30" PCCP SEWER FORCE MAIN REPLACEMENT

INVITATION FOR BID # PSUT-26-02

F - PSUT-26-02 – 30” PCCP Force Main Replacement - Addendum #1

FORCE MAIN PLAN & PROFILE	CITY OF PEMBROKE PINES 30-INCH PCCP FM REPLACEMENT SECTION 10 - TOWNSHIP 51 SOUTH - RANGE 41 EAST BROWARD COUNTY, FLORIDA
THIS SHEET NOT VALID FOR CONSTRUCTION WITHOUT COMPLETE SET OF PLANS. SEE GENERAL NOTES FOR MASTER LEGEND.	
Sheet No. C-6

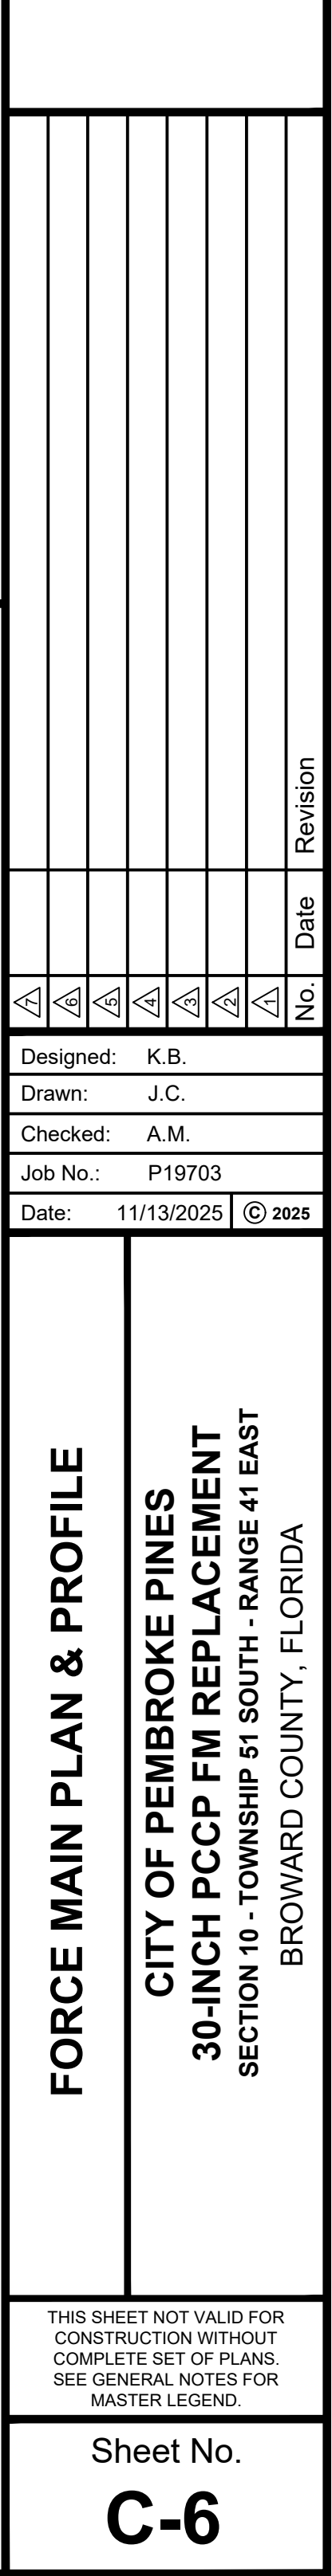
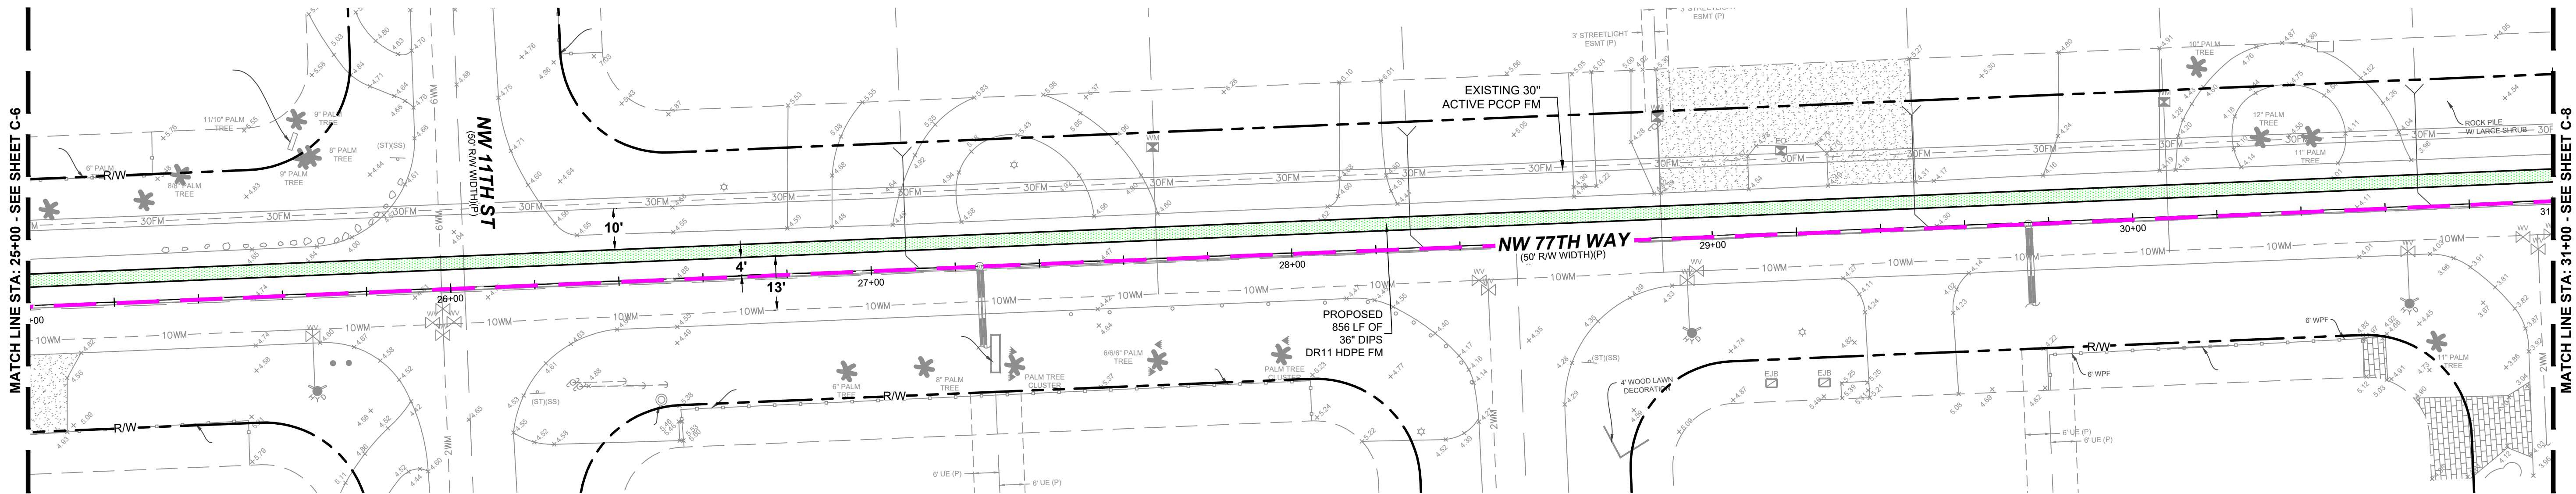
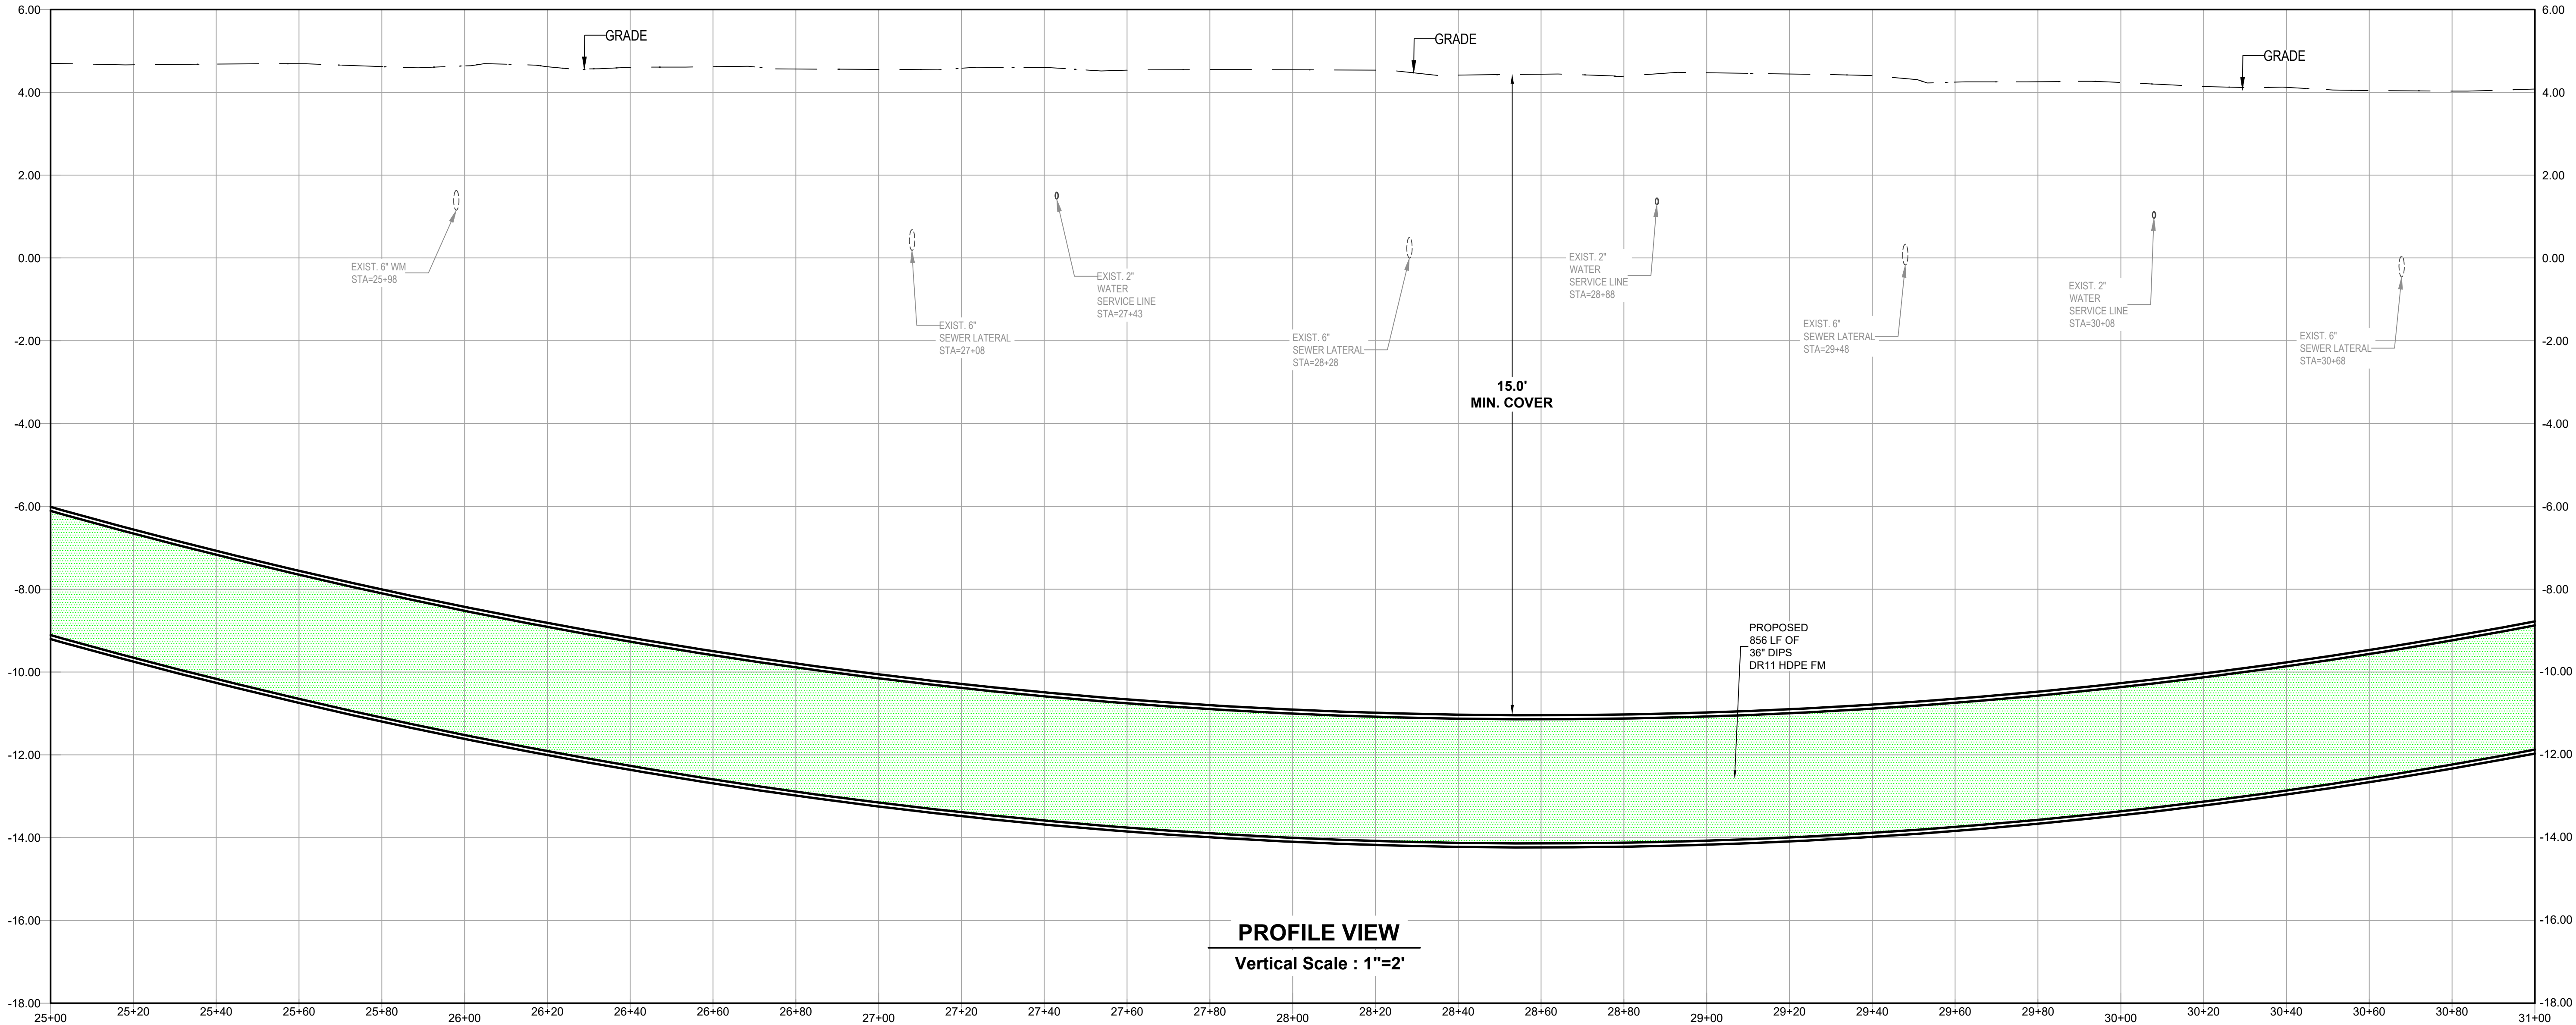
3. Sheet C-6 – The Proposed check valve at station 23+51.56 is hereby removed from the Scope of Work.
4. Sheet C-11 – The Proposed Offset ARV shall be installed with a dual strap service saddle as indicated in detail “TYPICAL STANDARD DETAIL MANHOLE AIR RELEASE VALVE” on Sheet C-13 not a 30X4 tapping sleeve and valve as annotated on this sheet. Offset shall be accomplished using 316L schedule 40 piping and fittings to accommodate a ¼”/foot slope back to the FM.
